*Staff Report Corrected 10/13/83
STAFF REPORT AMENDED 10-13-83
CITY PLANNING COMMISSION

- APPLICATION:
1. Variance to waive nine of required 96 parking spaces
 2. Variance to locate four-foot landscaping strip along 'R' Street and 24th Street on City right-of-way
 3. Variance to exceed the 30 percent compact parking space provision by three spaces
 4. Variance to waive masonry wall
 5. Lot Line Adjustment to combine two parcels (P83-302)

LOCATION: 1725-23rd Street

PROPOSAL: The applicant is requesting the necessary entitlements to convert an existing 38,400 square foot office/warehouse structure in a C-4 zone into 100 percent office use.

EXHIBIT 'C':

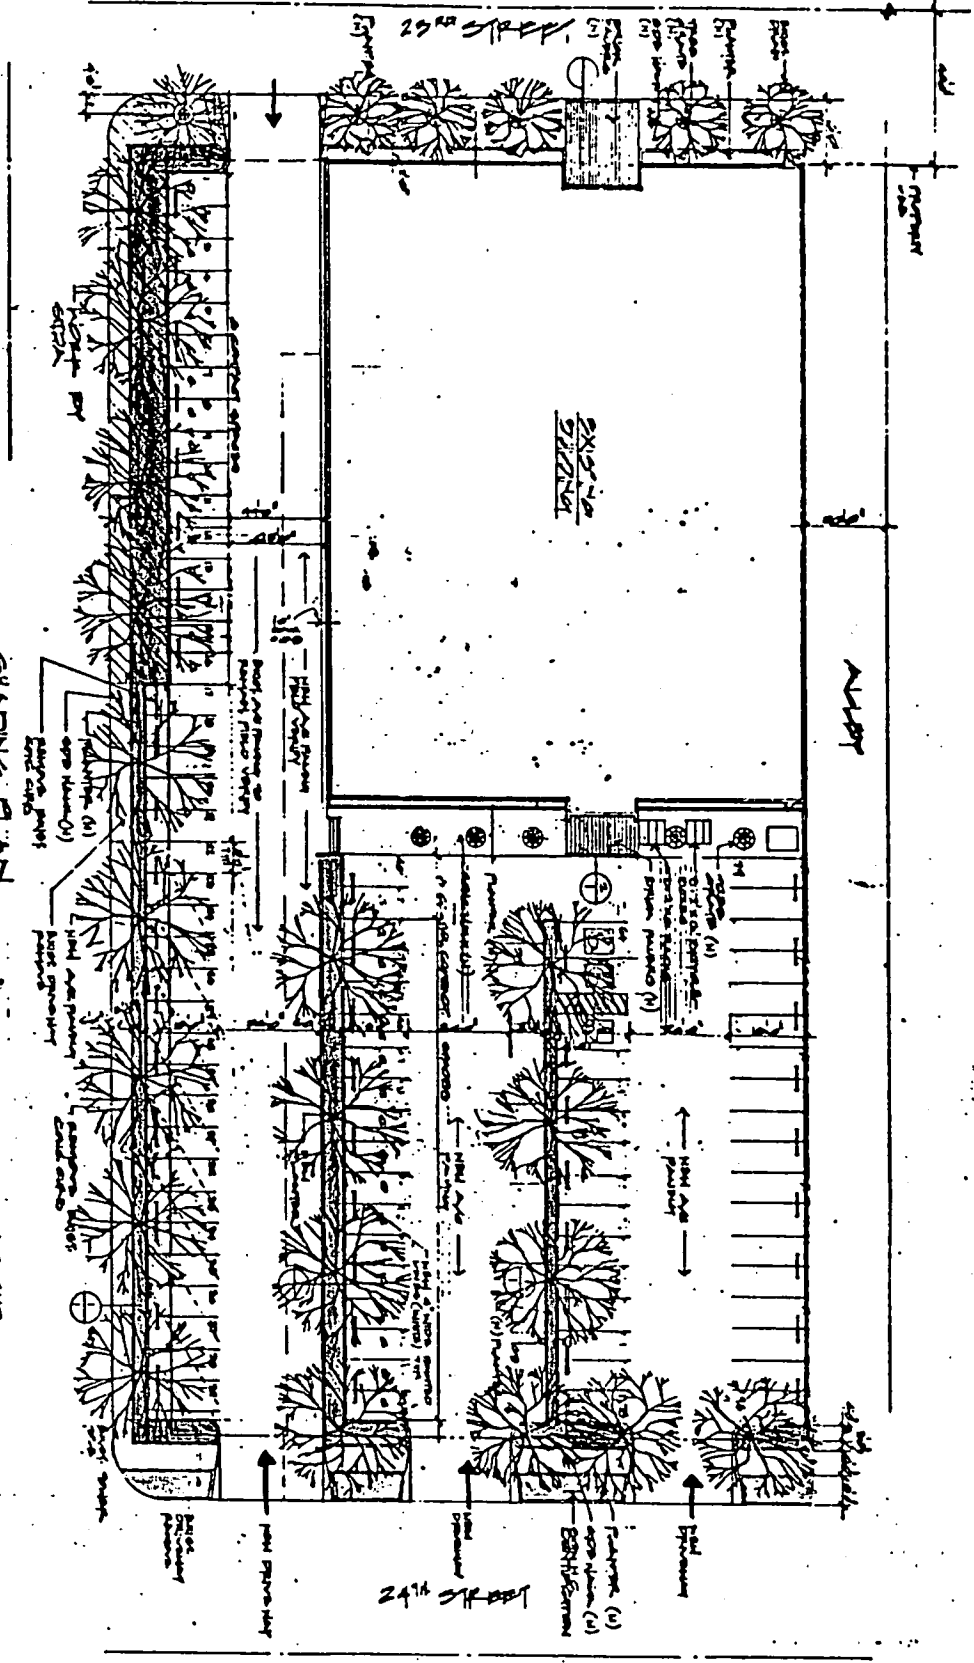
Parking had been previously approved on the basis of the then existing parking arrangement. It included two abutting but separate lots having no on-site connecting drives. That condition was due to a four-foot grade separation.

Subsequently, the applicant removed the retaining wall between the two lots as well as the surfacing of the upper level.

The retention of two separate lots has several adverse effects:

- a. The need for three driveways on the half-block fronting 24th Street creates unnecessary additional turning areas that conflict;
- b. Visitors will sometimes need to exit onto 24th Street to reenter the second lot. This is an inconvenience and adds to traffic on 24th Street;
- c. The driveways take up curb space that can be used for additional on-street parking.

Staff therefore suggests providing on-site connection of the two lots and the elimination of the two most southerly driveways.

The applicant's plan should be modified with a break in the separating planter near the 24th Street frontage and reorientation of several parking spaces in that area as provided on Exhibit D. In addition, the City Traffic Engineering Department has recommended that the two southerly driveways on 24th Street, as indicated in the applicant's proposal (Exhibit C), be eliminated. This would improve the overall circulation and reduce traffic congestion near 'R' Street.

- a. The parking lot shall be redesigned with a connecting drive as indicated on Exhibit D; (CPC amended to...as indicated on Exhibit E.)
- b. The two southerly driveways on 24th Street shall be ~~eliminated~~ (see Exhibit D); (CPC amended to...shall be provided as indicated on Exhibit E.)
- c. A wrought iron fence and landscaping shall be provided along the alley;
- d. Detailed landscape, irrigation and shading plans shall be submitted for staff review and approval prior to issuance of building permits;

SHADING PLAN
SITE PLAN
SOUND WALL

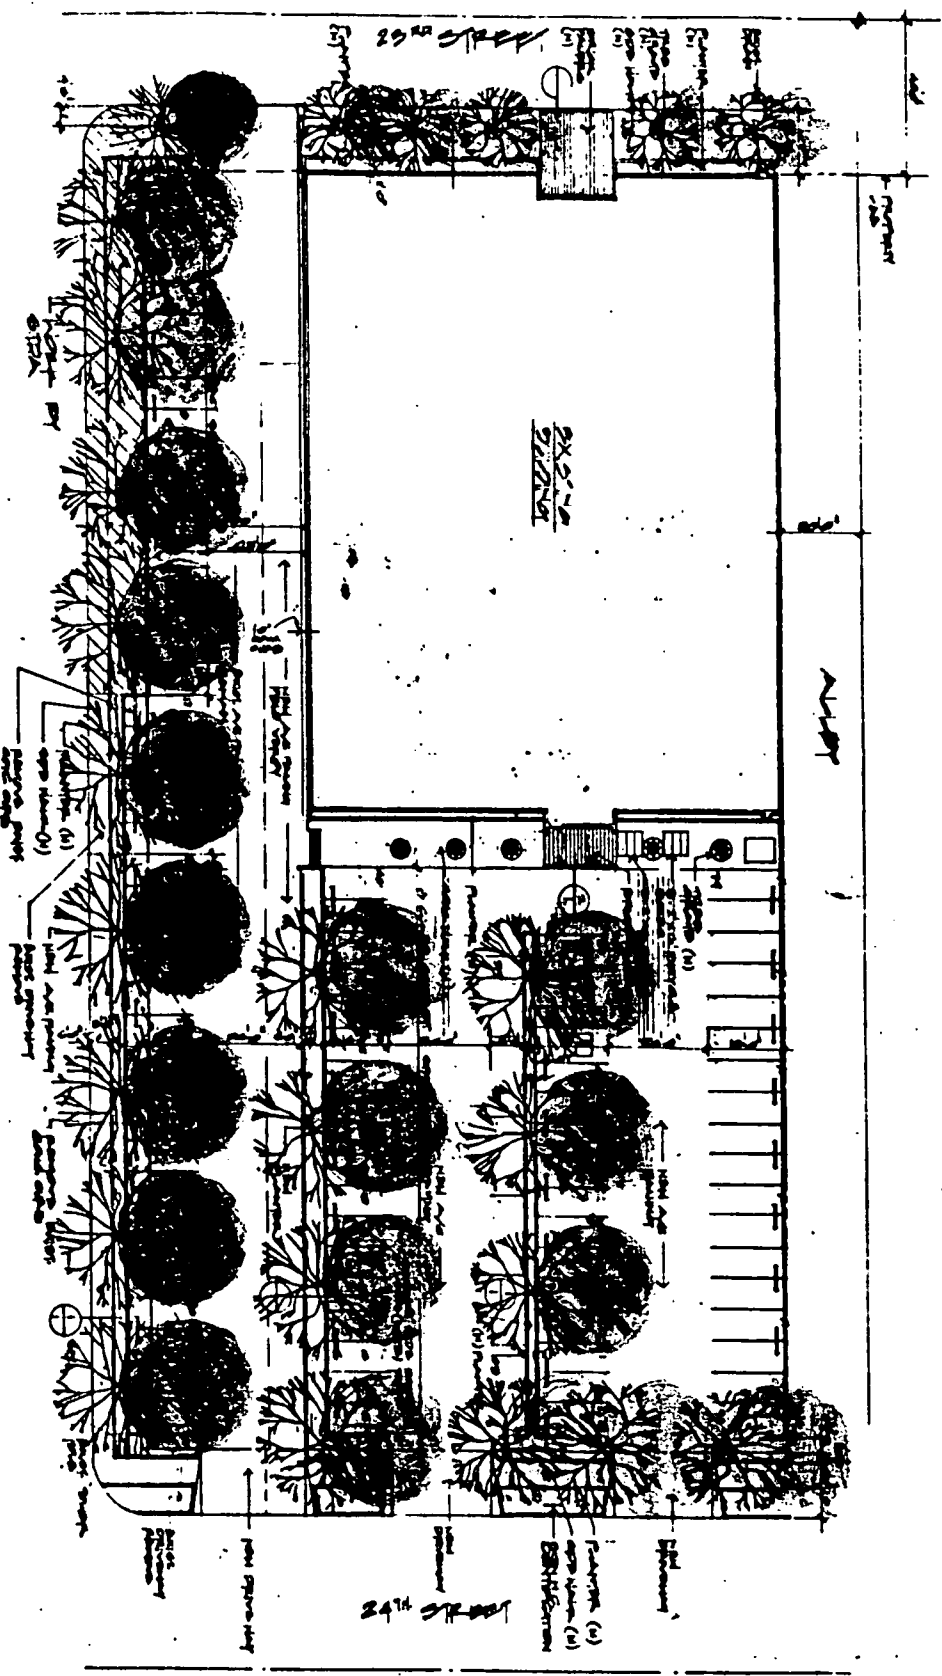
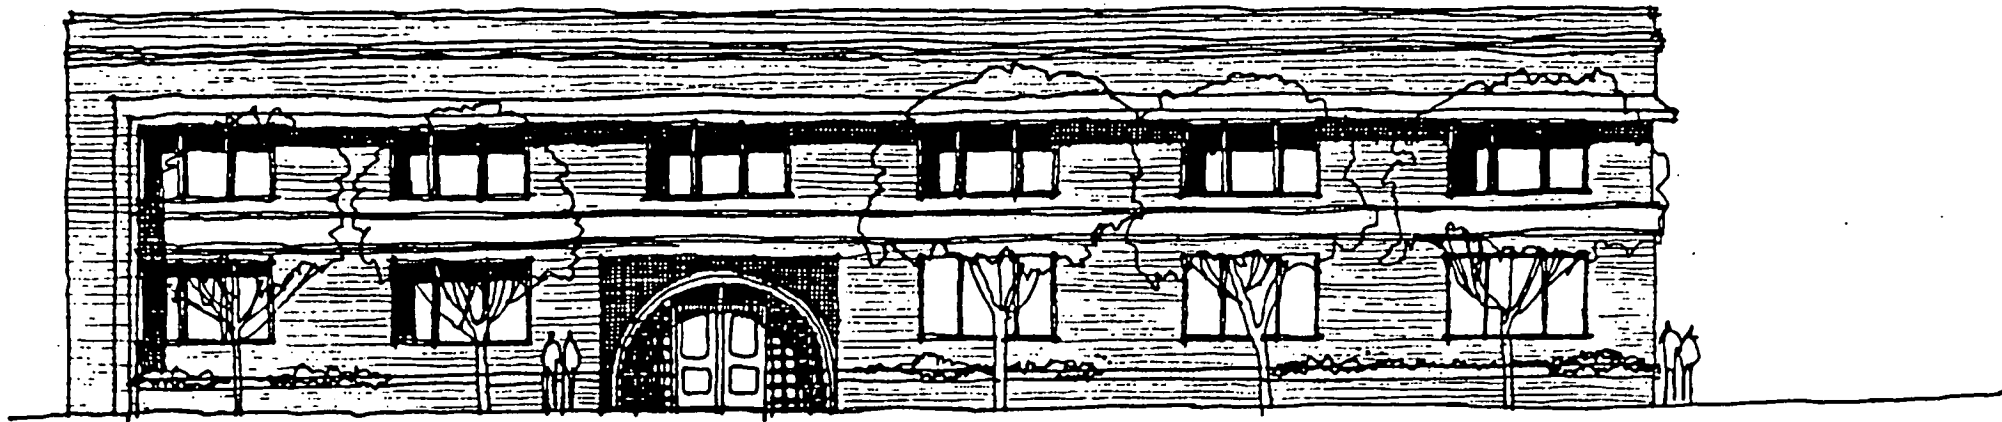
The presently proposed shading plan shows a four-foot planter in the City right-of-way along 'R' Street. Staff's only concern is that the trees selected for planting require a minimum of six-foot planter width. As there is no additional space to expand the width of the planter into the City right-of-way, the shade plan should be redrawn to: a) provide trees that can grow in a four-foot planter, and b) increase the number of trees if necessary to provide the required amount of shading.
